Informal document GRE-77-13
(77th GRE, 4-7 April 2017
agenda item 5)

Proposal for amendments to the original version of the Consolidated Resolution
on the common specification of light source categories

The changes to GRE/2017/06 are indicated as “track changes”

Main Drawing, L1A/6

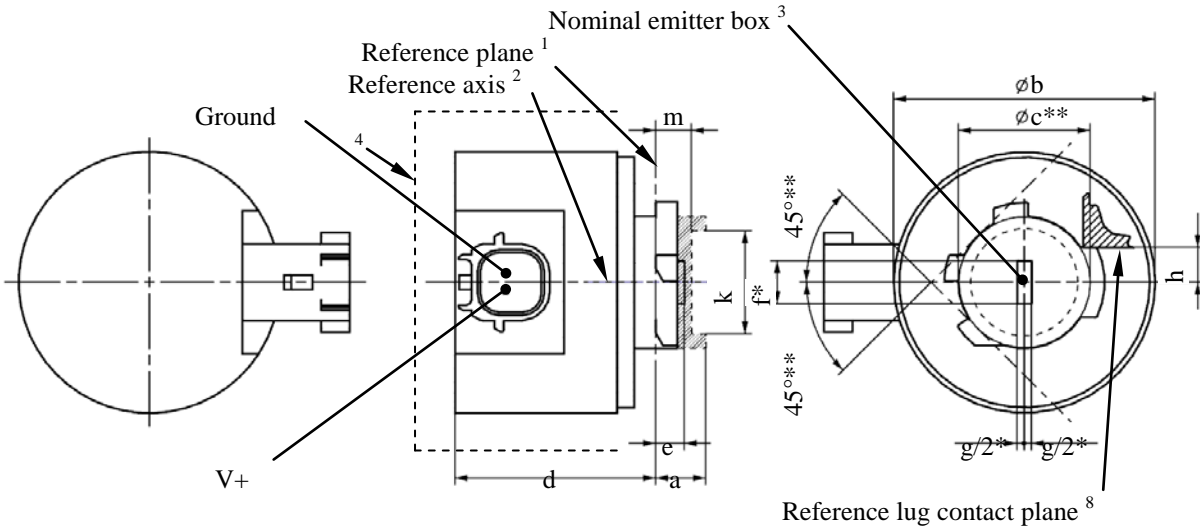
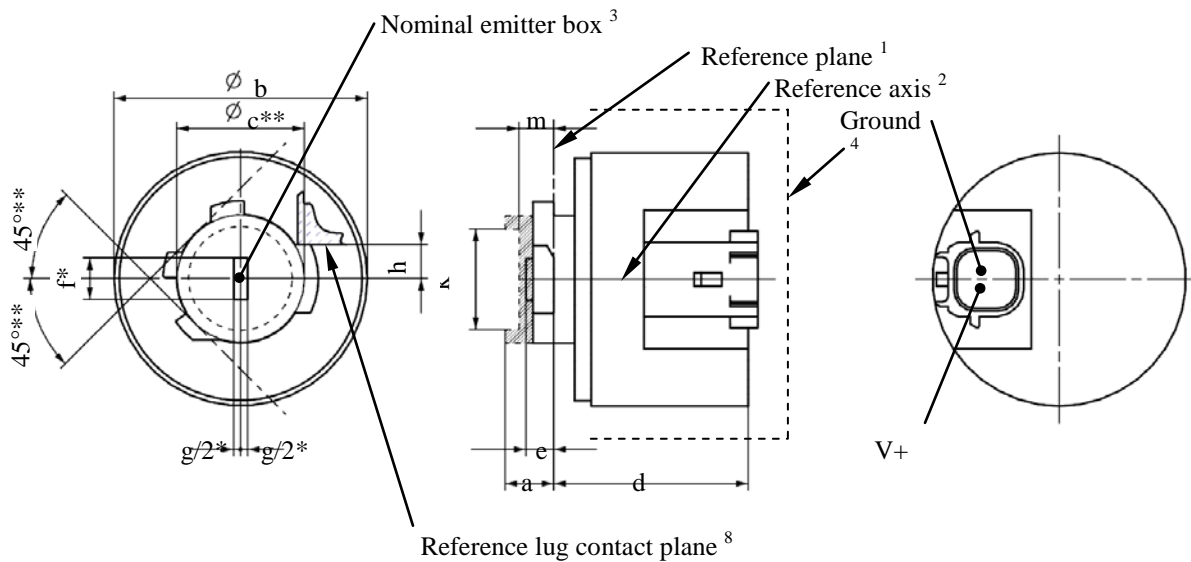
Before sheet LR1/1, insert new sheets L1/1 to 5, to read (see the following pages; one page per sheet):

Dimensions		Production LED light sources	Standard LED light sources	
a	mm	6.0 max.		
b	mm	c + 10.0 min. 38.0 max.		
c	mm	18.60		
d	mm	28.0 max.		
e	mm	3.00 ± 0.30	3.00 ± 0.10	
h ⁸	mm	4.88		
k ⁹	mm	7 min.		
m ⁹	mm	4.5 max.		
Cap [PGJ18.5d-29a] for thermal grade [65] in accordance with IEC Publication 60061 (sheet 7004-185-[2]) ¹⁰ Cap [PGJ18.5d-29b] for thermal grade [85] in accordance with IEC Publication 60061 (sheet 7004-185-[2])				
<i>Electrical and photometric characteristics⁵</i>				
Rated Values	Voltage (in Volts)		12	
	Power (in Watts)		L1A, L1B 4.0	
Objective values ⁶	Power (in Watts)	at 13.2V DC at 13.5V DC	L1A, L1B 6.0 max 6.0 max	
	Luminous Flux (in lumen)	at 13.2V DC at 13.5V DC	L1A, L1B 350 ± 20% 355 ± 20%	350 ± 10% ⁷ 355 ± 10%
	Luminous Flux (in lumen)	at 9V DC	L1A, L1B	70 min.
Thermal grade (in degree Celsius)		L1A [65], L1B [65] L1A [85], L1B [85]	[65]°C [85]°C	
<i>Characteristics of the light-emitting area</i>

Contrast		[100]150 min.	[200]150 min. 250 max.	
Size of light emitting area in relation to size of nominal emitter box ³		75% min.	75% min.	
Uniformity R _{0,1} – surface ratio with luminance exceeding 10% of average luminance		75% min.	85% min.	
Uniformity R _{0,7} – surface ratio with luminance exceeding 70% of average luminance		55% min.	65% min.	
<i>Specific thermal test conditions</i>				
Maximum test temperature		65°C	65°C

Figure 3

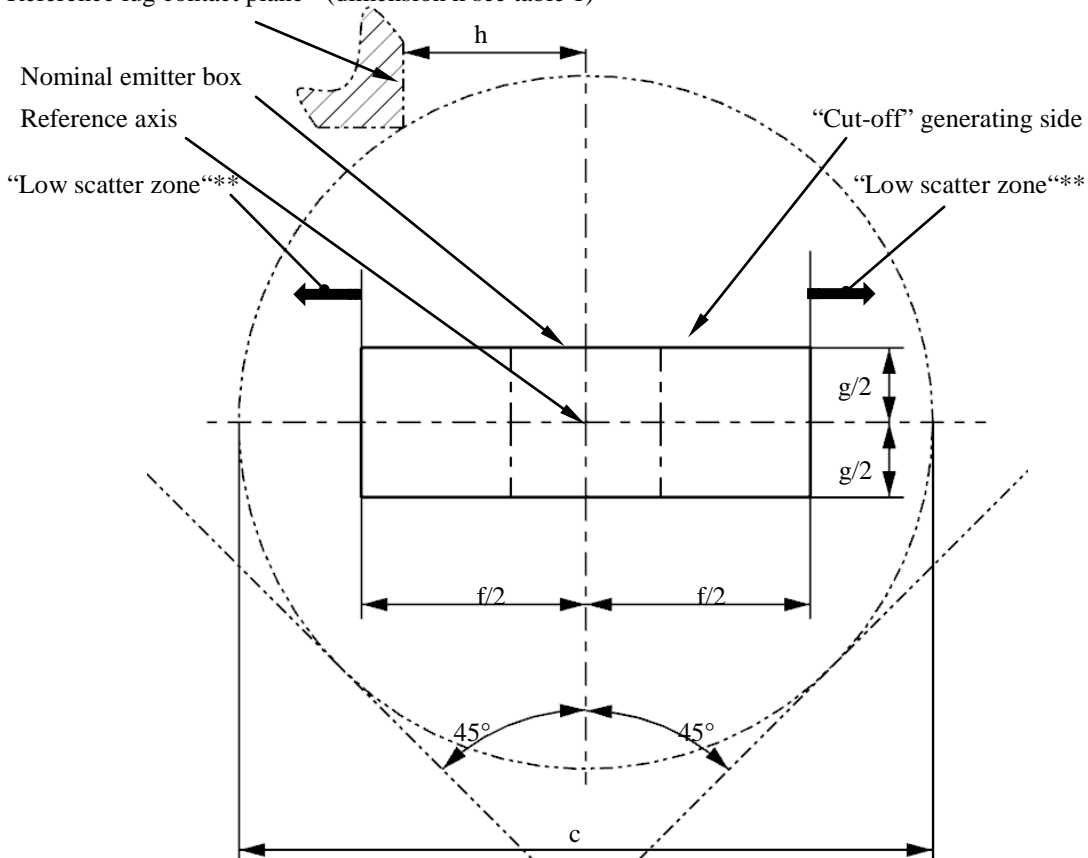
Definition of the nominal emitter box with dimensions as specified in table 2

Product type	L1A, L1B	
Dimensions	f	g
LED light sources of normal production	mm 4.0	[1.2]1.4
Number of equidistant subdivision to control deviation of luminance	3	2

Figure 4
Set-up to measure the luminous intensity distribution for L1A/6

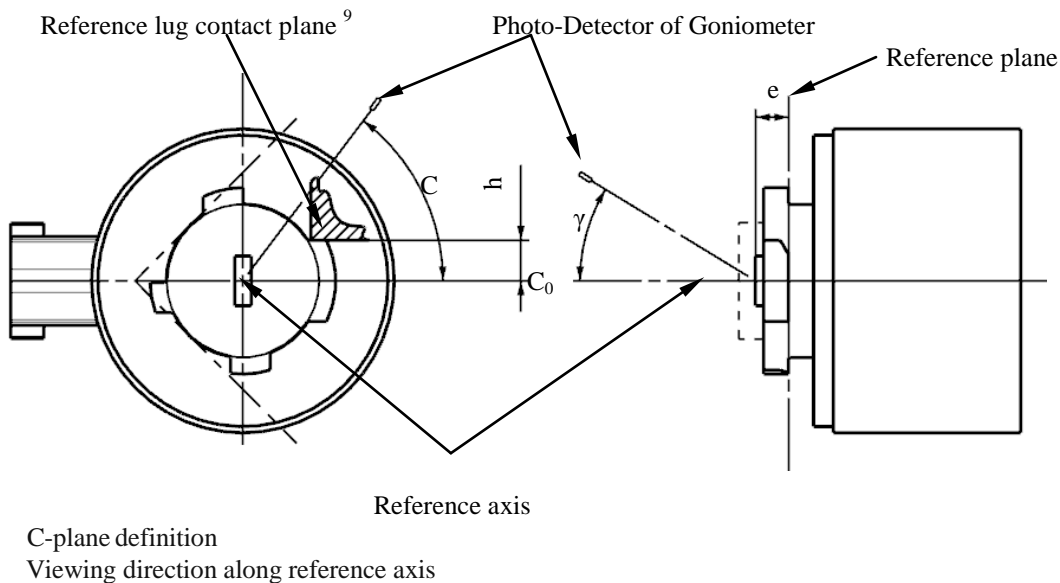
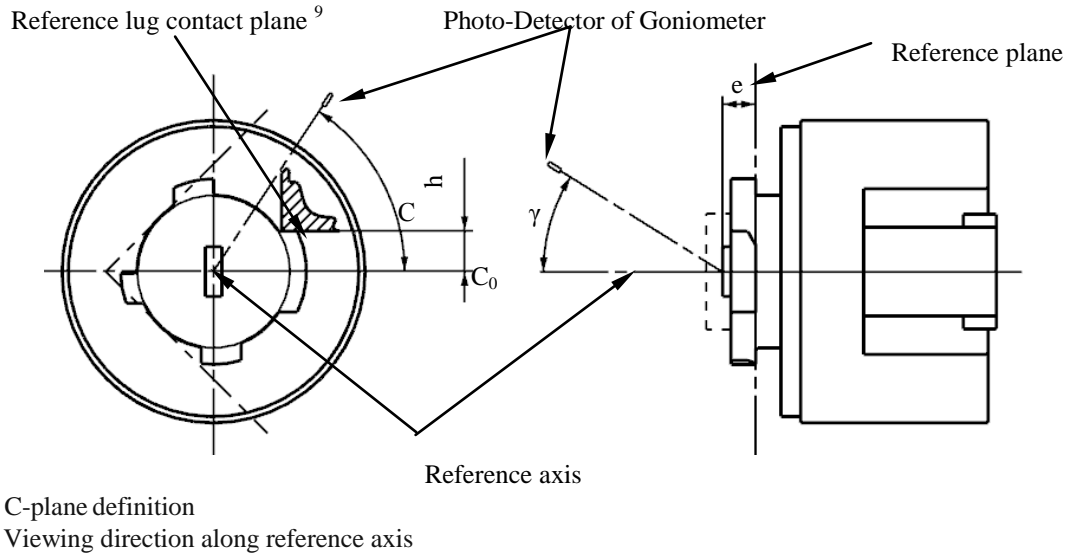
The measurements shall be performed in C-planes C_0 , C_{90} , C_{180} and C_{270} , which contain the reference axis of the light source. The test points for each plane for multiple polar angles γ are specified in Table 3.

After measurement the data shall be normalized to 1000 lm according to Paragraph 3.1.11 using the luminous flux of the individual light source under test. The data shall comply with the tolerance band as defined in Table 3.

Angle γ	LED Light sources of normal production and Standard LED light sources	
	Minimum Intensity in cd/1000 lm	Maximum intensity in cd/1000 lm
	$C0^\circ / C90^\circ / C180^\circ / C270^\circ$	$C0^\circ / C90^\circ / C180^\circ / C270^\circ$
0°	266	389
15°	257	376
30°	228	339
45°	183	281
60°	123	205
70°	70	149
75°	40	116
80°	0	84
90°	0	21
